Remarks

Reference is made to the marked-up drawings. Entry of the replacement sheet drawings is respectfully requested.

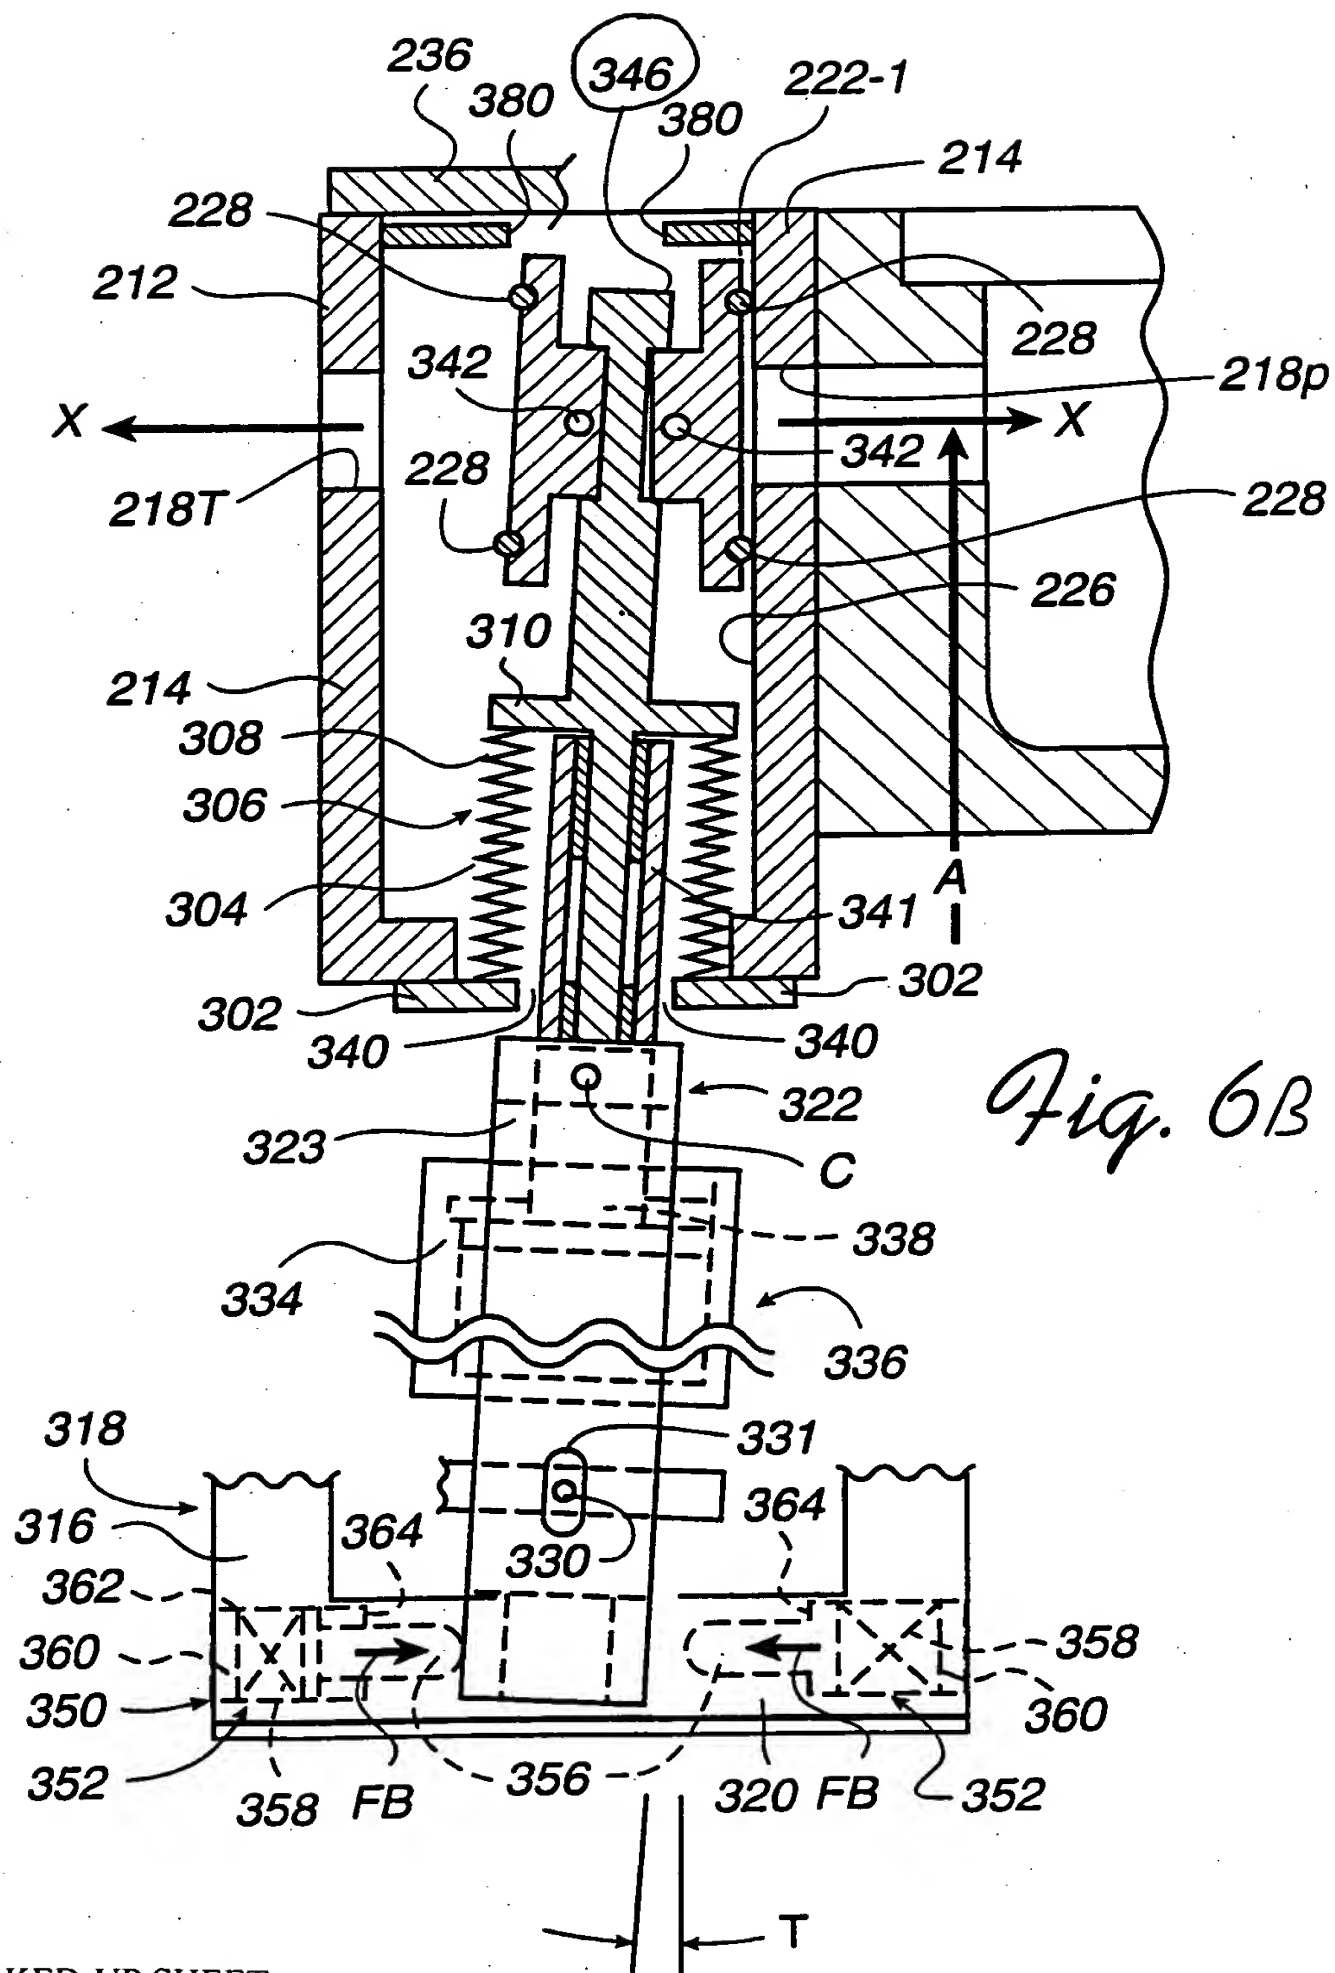
In Figure 6B, a circle identifies the reference number 346 (and lead line) which have been removed because no such number is referenced in the description.

Fig. 6c

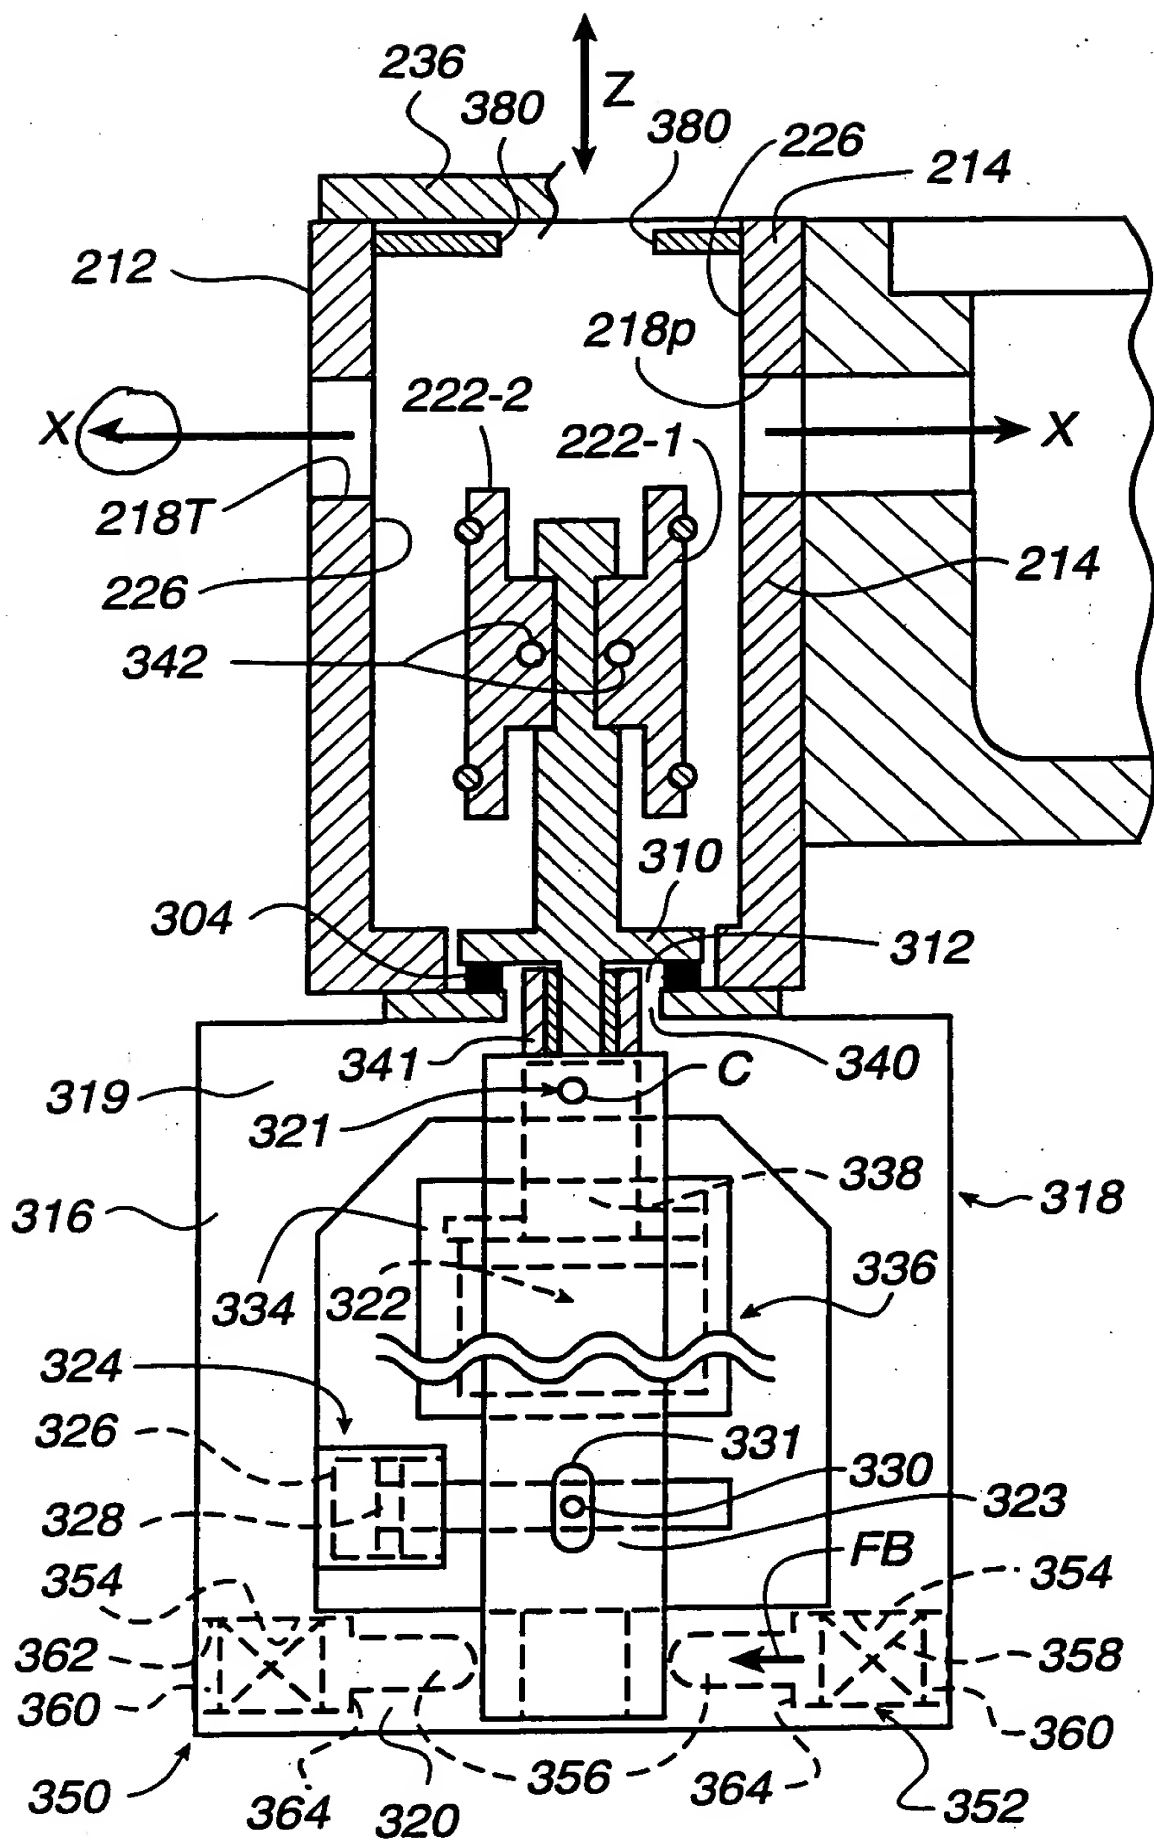
In Figures 6A and 6C, a circle in each Figure identifies an arrowhead that has been corrected.
